Bareburger – The Shops at Somerset Square, 140 Glastonbury Boulevard.

**RE: 24/08/24 ASDRC Report response letter.**

This letter is in response to the 24/08/24 ASDRC Report comments on the proposed patio for the Bareburger restaurant at The Shops at Somerset Square. The following bullet point list describes all updates and changes made to the set. All bulleted items are clouded on each drawing with delta #2.

*Figure 2 Black wooden enclosure adjacent to the building. New black fence will apport a more cohesive image at The Shops at Somerset Square*

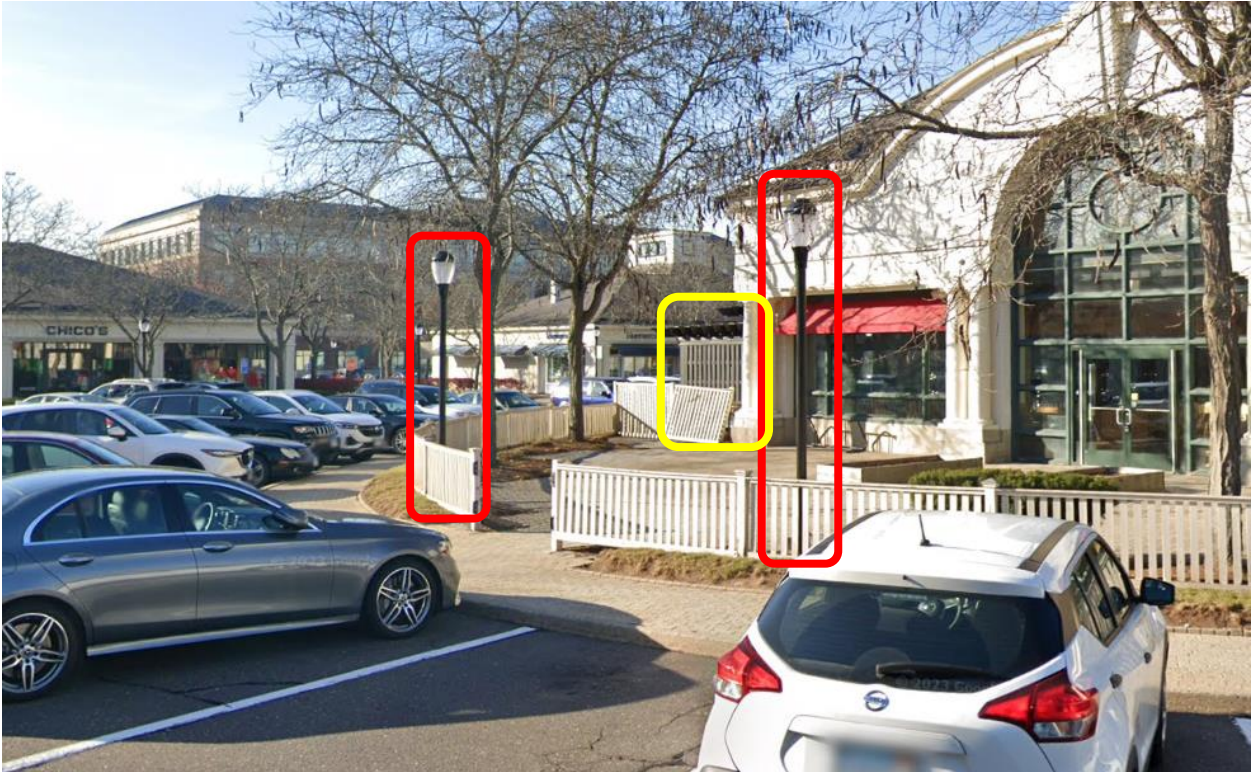
4. Proposed black vinyl fence does not fit in with overall design context of Somerset Square. Applicant should either repair existing fence or propose a fence that matches the existing fence

- **New fence by Total Fence LLC, to replace existing. Total Fence LLC is the original vendor for the existing fence. New fence to match existing fence's material, design and sizes. supply & install approx 128' of 3' high and 13' of 6' high custom spaced picket cedar fencing with one 3' high x 3' wide single swing gate. (this is the side door for egress which will remain) includes 4" x 4" pressure treated posts with decorative wood post caps. All materials to match existing, and be painted black to match the aesthetic of Somerset Square: Benjamin Moore PM-9 (black). Other site elements and urban furniture, like lighting posts or adjacent wooden enclosure, are all black. This color choice ensures consistency in the color palette, maintaining a cohesive visual environment that respects the center's design language.**

Landscape Plan: Patio-landscape plan

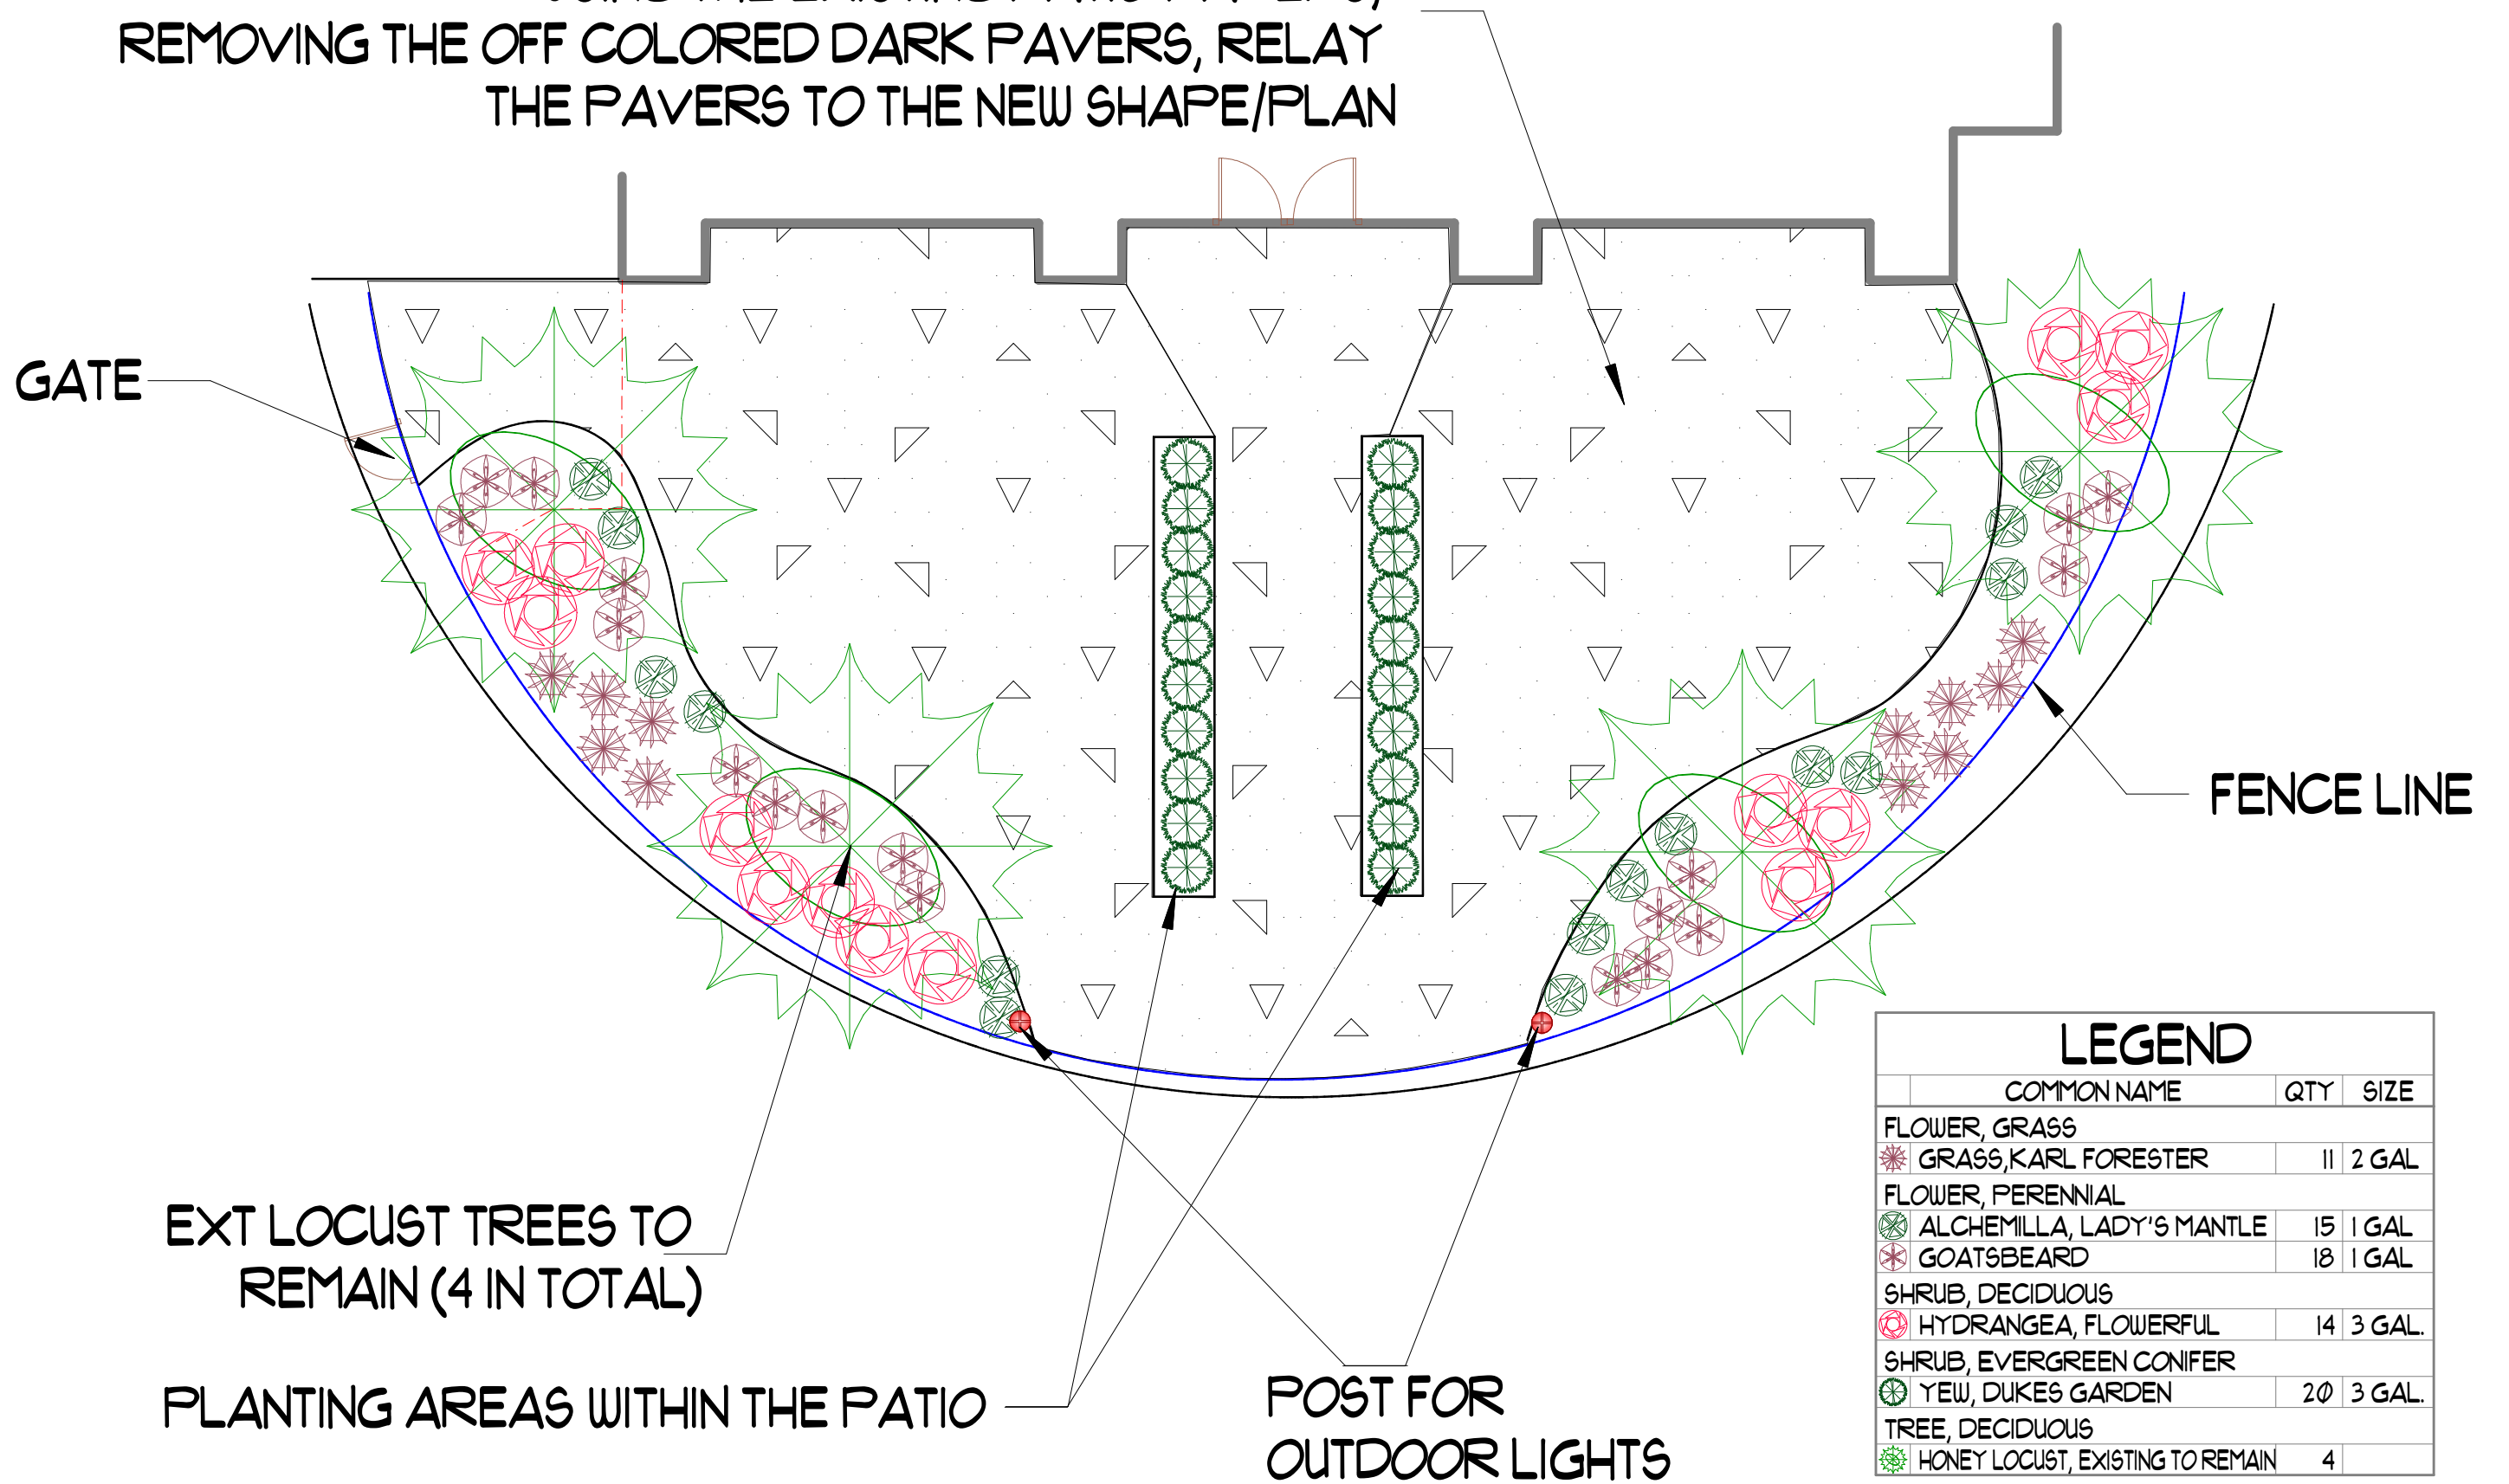
2. Applicant should replant barren planted beds as originally approved or submit a landscape plan to replant these areas
  - **Refer to new landscape plan by General Landscaping. New landscape areas and central planting area are being proposed, with new native plants, and plants previously used at The Shops at Somerset Square**

3. Patio area is in disrepair and needs to be redone, applicant should either repair or replace existing patio pavers to match existing patio pavers
  - **General Landscaping to remove all existing pavers and level the ground to prepare for reinstallation of pavers. Existing pavers to be cleaned and reused to re-pave the patio. Any new pavers needed will match the size and color of the existing pavers.**

PROPOSED PATIO TO BE RENOVATED  
 USING THE EXISTING PATIO PAVERS,  
 REMOVING THE OFF COLORED DARK PAVERS, RELAY  
 THE PAVERS TO THE NEW SHAPE/PLAN
